SUBJECT: FINAL RESPONSE TO TASK INTERFACE AGREEMENT 2014-02,
INTERPRETATION OF AMERICAN SOCIETY OF MECHANICAL
ENGINEERS CODE, SECTION XI, TABLE IWB-2500-1, NOTE 1

TASK INTERFACE AGREEMENT 2014-02

ASME CODE, SECTION XI, TABLE IWB-2500-1

NOTE 1 INTERPRETATION

Figure 1 – Side View of RPV Support

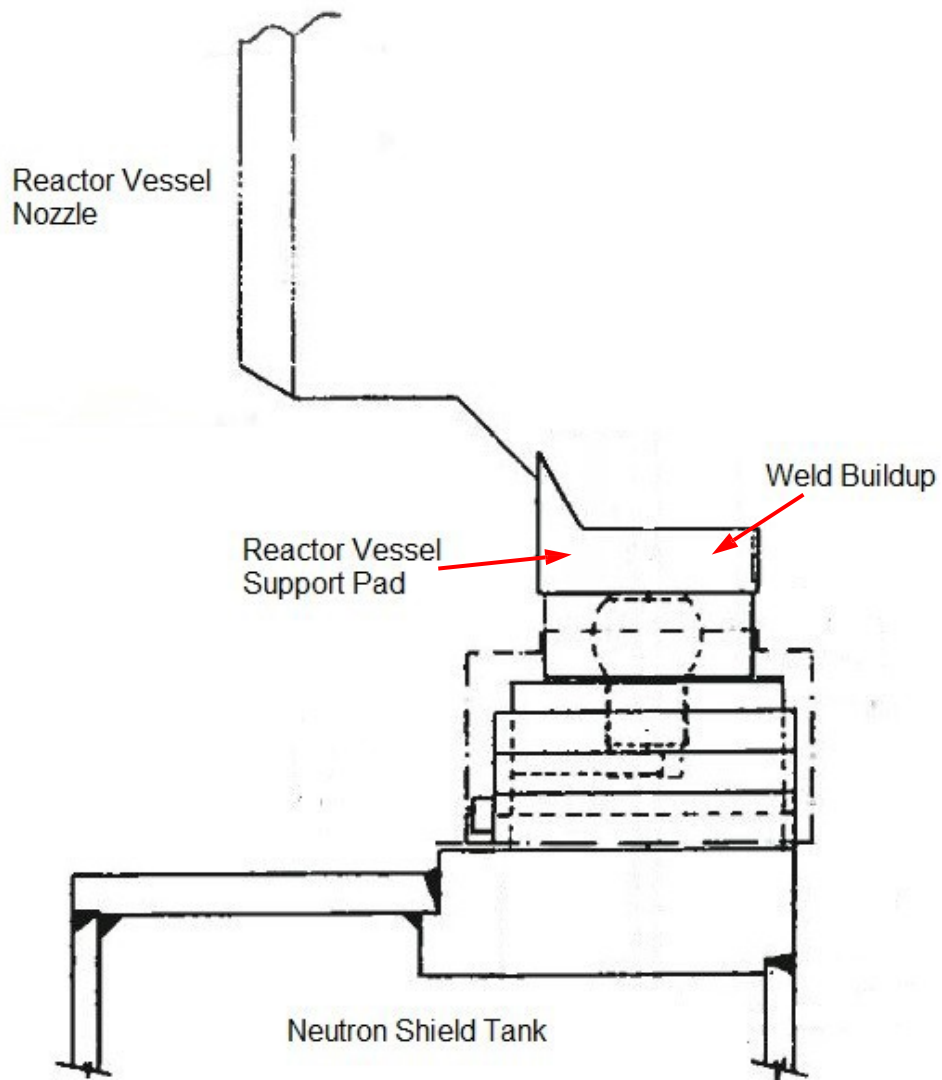
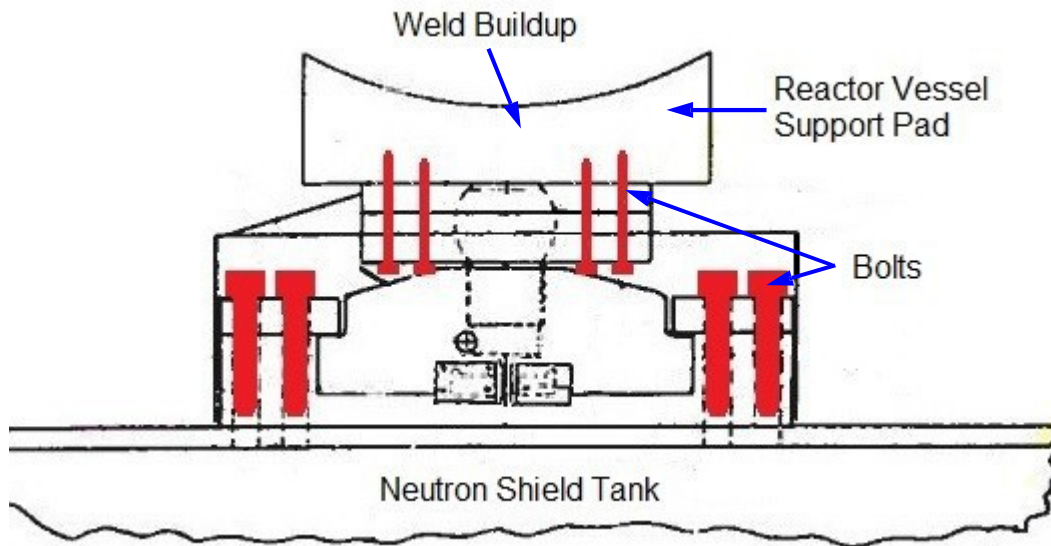
Region II inspectors reviewed design basis calculations and drawings for the Surry, Unit 1, RPV supports, and identified that “normal case” loading conditions on the supports included both compressive and shear loads. The calculations provided in Reference 1, show normal case support loads to be in both vertical compression and horizontal directions. The design drawings showed no attached member to the pressure boundary, as described in Figures IWB-2500-13, -14 and -15. However, the drawings did show a weld build-up on each RPV nozzle, which serves as the attachment point used for the transfer of loads from the nozzle to the building structure.

The ASME BPVC, Table IWB-2500-1, Note 1, states, in part, that a weld build-up on nozzles that is in compression under normal conditions, and provides “only component support,” is excluded from examination. In Surry’s case, the support supplies not only reactor component support, but also serves as a sliding anchor that transfers loads imposed by the reactor coolant system (RCS) piping to the neutron shield tank intervening element, and then to the building structure. The licensee’s calculations clearly show the loads that are supported come from the RCS piping loads and the reactor, not just the reactor component.

The loads imposed on this support location from the RCS piping, which are typically offset by reactor dead weight loads, can only be transmitted to the building support structure through the weld build-up on the reactor nozzle. The support includes a mono-ball assembly mounted to the weld pad build-up by plates, cap screws, and dowel pins. Through additional plates, and the threaded end of the monoball, the support is also provided with vertical hold down plates for any upload case. This arrangement transfers RCS piping loads and reactor loads to the intervening elements of the neutron shield tank, which are then resolved to the building structure. This configuration makes the weld build-up, screws, and dowel pins mounted to it, part of the support load path that will induce tensile and horizontal loads in the nozzle weld build-up pad, and the RCS nozzle pressure boundary, under certain load conditions. The load tables in Reference 1 provide loads consistent with this configuration. Figures 1 and 2 provide a general sketch of the RPV support configuration.

The support under discussion is used in the licensee's calculations (Reference 1) as a support for the reactor vessel, and is also used as a sliding anchor type restraint to transfer loads imposed by the RCS piping through the weld build-up, and other support assembly members, to the neutron shield tank upper surface components and ultimately into the building structure. The support provides four directions of restraint; two vertical directions and two horizontal directions and along with associated moments, and is typically referred to as a sliding anchor support.

Reference 1, Table 6.1.1, provides load tables showing both a vertical compressive load maximum of 290.5 kips, and maximum shear load of 16.59 Kips, not just a compressive load under normal conditions, as described in IWB-2500-1 Table, Note 1. Likewise, Table 6.1.2, "Surry Unit 1 & 2 Deadweight Loads," provides a vertical load of 81.44 kips compressive load, and a 6.32 kips shear load due to the connected RCS piping. [Note that these loads are not component support loads caused by supporting the reactor component itself, as is described by Note 1 of the ASME Table IWB 2500-1.]

1. Contrary to the requirements of IWB-2500-1, Note 1, the Reference 1 calculation provided by Dominion includes horizontal loads under normal load conditions, and includes loads imposed by the RCS piping, not just the loads imposed by the reactor vessel component.

Please provide the NRR position on the acceptability of using Table IWB-2500-1, Note 1, as the exclusion criteria basis for not performing the prescribed surface examination of the weld

build-up to reactor nozzle outer surface; when the weld build-up configuration is as described above for the Surry sliding anchor support configuration.

It is the position of NRR staff that it is acceptable to use Table IWB-2500-1, Note 1, as the exclusion criteria basis for not performing the prescribed surface examination of the weld build-up to reactor nozzle outer surface; when the weld build-up configuration is as described above for the Surry, Unit 1, sliding anchor support configuration, when the stress due to a horizontal shear force does not exist or the conditions (a) through (d) in Note 1 are not met.

The reactor vessel support for Surry, Unit 1, does not have an attachment weld that joins an attachment directly to the surface of the component or integrally cast or forged attachment to the component. Therefore, a surface exam is not required. To consider the significance of not performing a surface examination of this support, the NRR staff determined the maximum tensile stress intensity due to the shear load to be 389 psi based on Reference 1, Table 6.1.1. This is compared to the Pm +Pb allowable for SA-302 Gr. B in accordance with ASME BPVC Subsection NF, 1998 Edition. The allowable is 34,350 psi. This load is negligible even if it were cyclic.
